Access Compliance Report

Public Rights-of-Way

(Curb Ramps)

Intersection ID: 5827	Main Street: ST_JOSEPH_DR	Cross Street: OLSEN_LN	Location: S
ADA ID: F7F782B87F28	Ramp Type: BlendTrans1	Initial Pass/Fail: Pass	Overall Compliance: No
Severity Score: 17.5			
Codes/Mitigation Info/Possible Solution		Field Measurements/Component Compliance

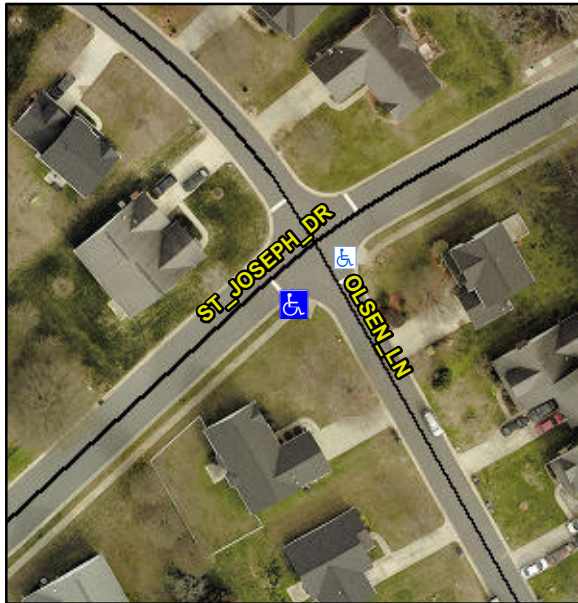
NO LT SW

R304.2.2-Perp, R304.3.2-Para, R304.5.3, R305, R302.7.2

Remove & Replace Curb Ramp With Two New Directional Ramps or Equivalent. Remove & Replace Gutter.
